INDESIT company

Model type:
IDL55EU

Commercial code:
F030634

N1045072FIG1

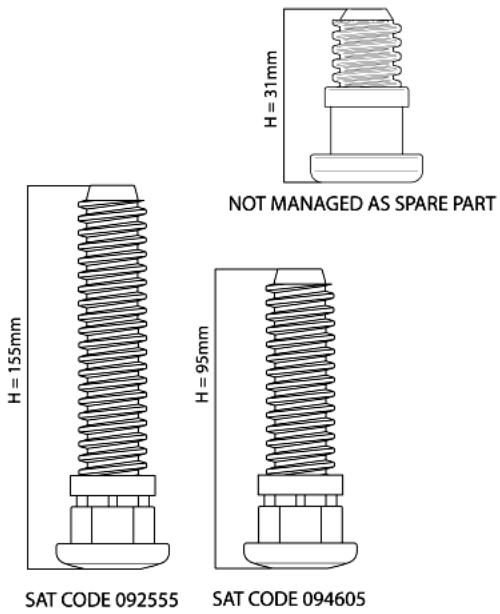
N1045072: Introduction of fixed rear foot H=31mm on free-standing models.

From serial no. 40218.0001, free-standing dishwashers affected by this modification have been equipped with new fixed rear feet (H=31mm).
The new foot replaces the adjustable one (H=155mm) Service code 092555; on the EVO3 range with TurboDry the new foot replaces the adjustable foot (H=95mm) Service code 094605.
The Spare Part Warehouse will continue to manage only 155mm and 95mm adjustable feet as they are interchangeable with the fixed 31mm foot.
The three feet are shown in illustration N1045072FIG1.

N1045083FIG1

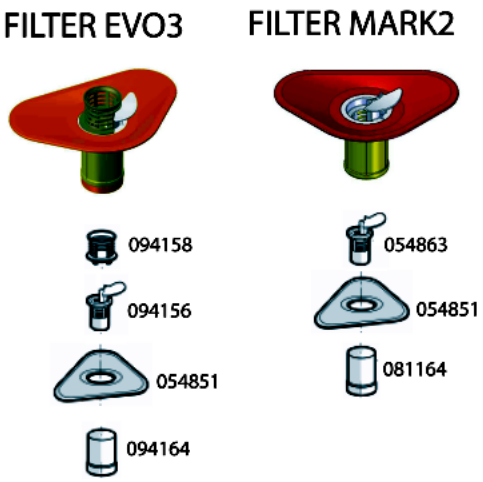
n1045083: Modification of filters on EVO3 60 cm dishwashers

All dishwasher models affected by this modification have been equipped with the items listed below, in order to solve the drain pump clooging problem.

Introduction of:
Cylindrical plastic filter code 081164
Central filter code 054863

Elimination of:
Cylindrical plastic filter code 094164
Central filter code 094156
Central filter grid code 094158

The modification has been introduced progressively, starting from serial no. 40516.0001.

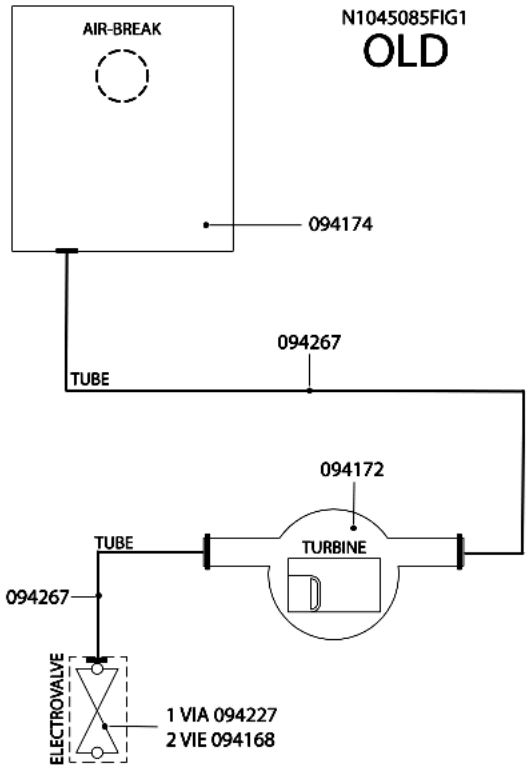
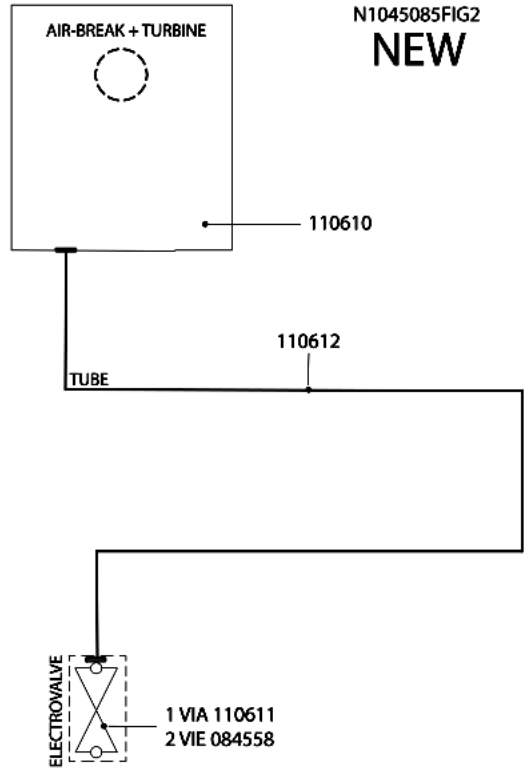
n1045085: Introduction of new litre counter turbine integrated on air-break.

All dishwashers affected by this note have been equipped with a new litre counter turbine on the air-break.
Picture N1045085FIG1 illustrates the premodification structure, picture N1045085FIG2 the new structure.

Items affected by the modification.

AIR-BREAK:
new 110610;
premodification 094174;
the new item features a new integrated litre counter turbine and its water supply hose has a smaller diameter.

LITRE COUNTER TURBINE code 094172 has been eliminated.

SOLENOID VALVES:
new:
1-WAY code 110611;
2-WAY code 084558(Rohs 143737);
premodification:
1-WAY code 094227;
2-WAY code 094168;
the new solenoid valves have a smaller diameter drain hose fitting.

HOSES:
new solenoid valve hose/air-break code 110612;
premodification turbine hose/air-break code 094267;
premodification solenoid valve hose/air-break code 094267;
the new hose has a smaller internal diameter.

WIRING:
the litre counter turbine connecting cable is longer, but since the connector is the same, the new item can be used in place of the premodification one.
